Request for a change of the PSB 4L1-R2 wire scanner

Ray VENESS / BE-BI

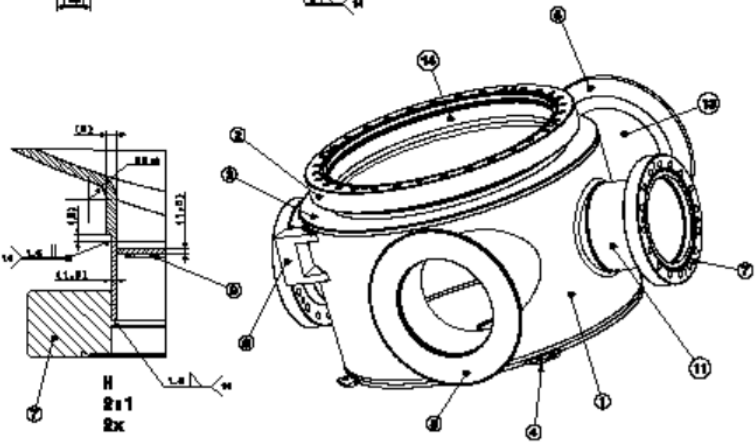
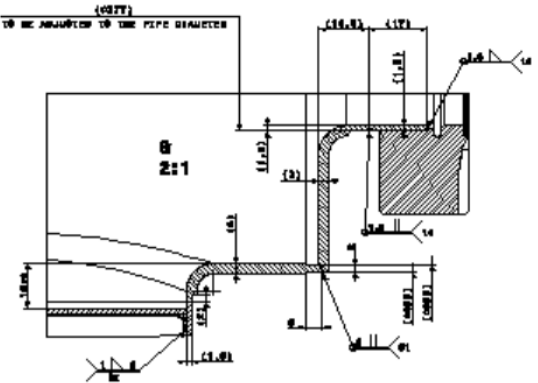
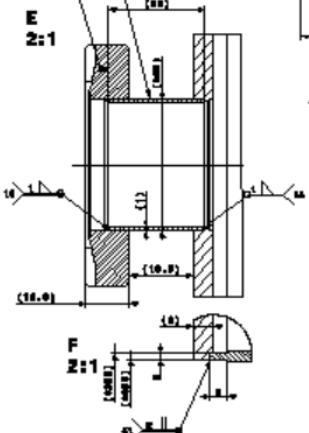
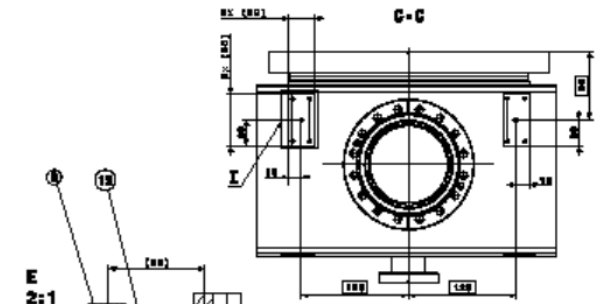
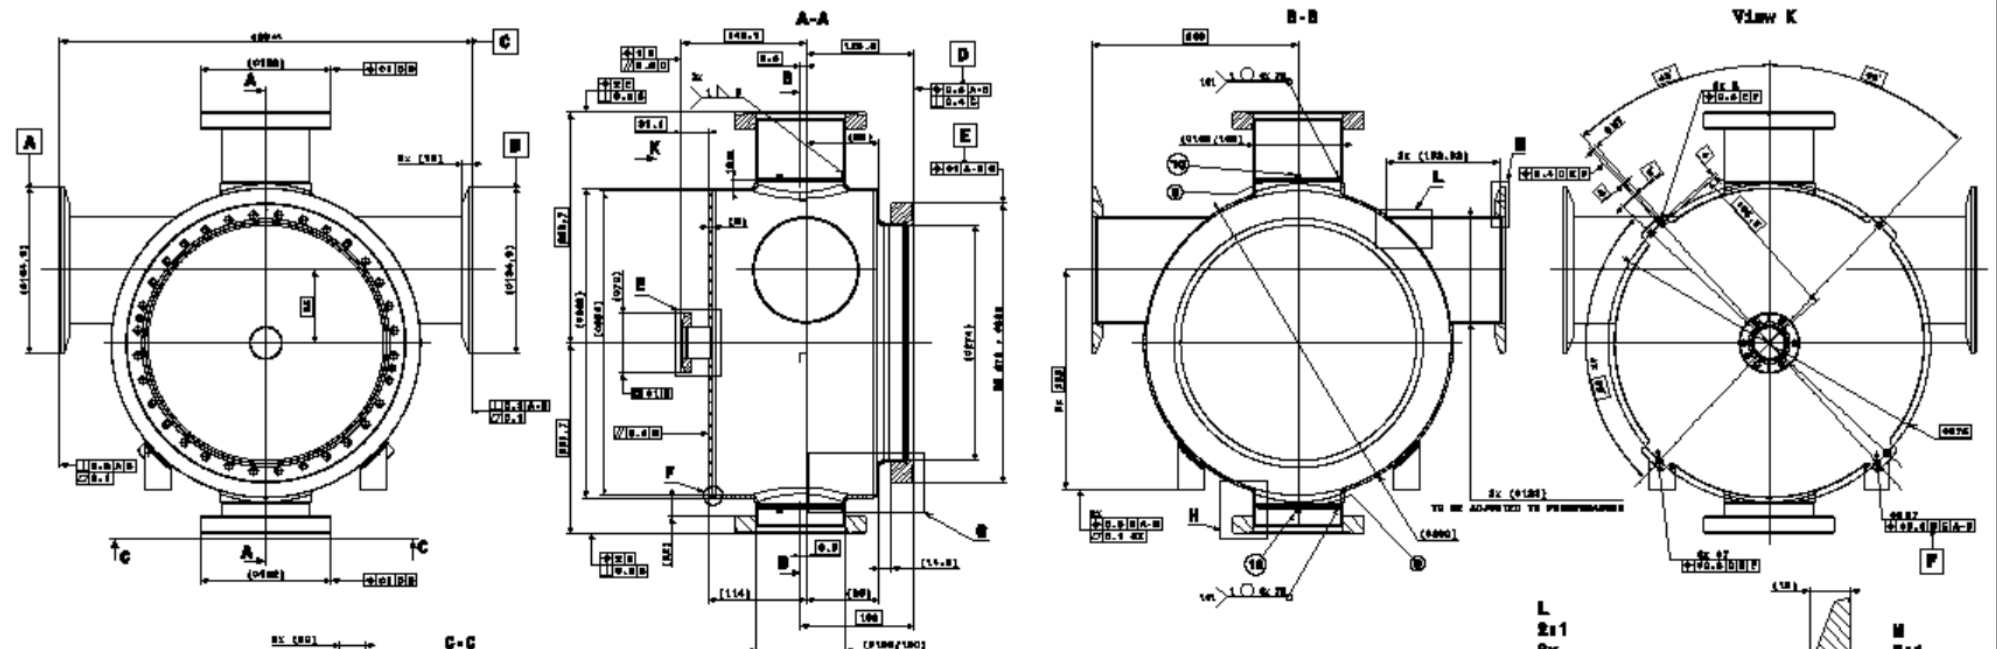
- It has now been determined that there is a design/fabrication dimensional error in this one vacuum tank
 - The error is just large enough that the deflection of the tank under vacuum ($\sim 0.4\text{mm}$) will block the scanner shaft against the tank wall, but not so large as to prevent the instrument seal from closing normally

- This means that the problem only appears when the scanner is under vacuum. This has been verified by venting the sector and operating at atmospheric pressure – the error is systematically repeatable

- Replace the scanner and tank assembly
 - Fortunately a spare scanner tank was produced for all variants and this exists for the PSB-H design. This spare tank is conforming to requirements and has been re-cleaned and prepared

- Ad-hoc meeting yesterday with OP, VSC plus other discussions has converged on a proposal for a **vacuum intervention on Tuesday 5th Jan 2021**
 - The complete assembly of tank + scanner will be removed and replaced with the spares, then re-surveyed. This intervention (not including vacuum recovery) will take less than 1 day.
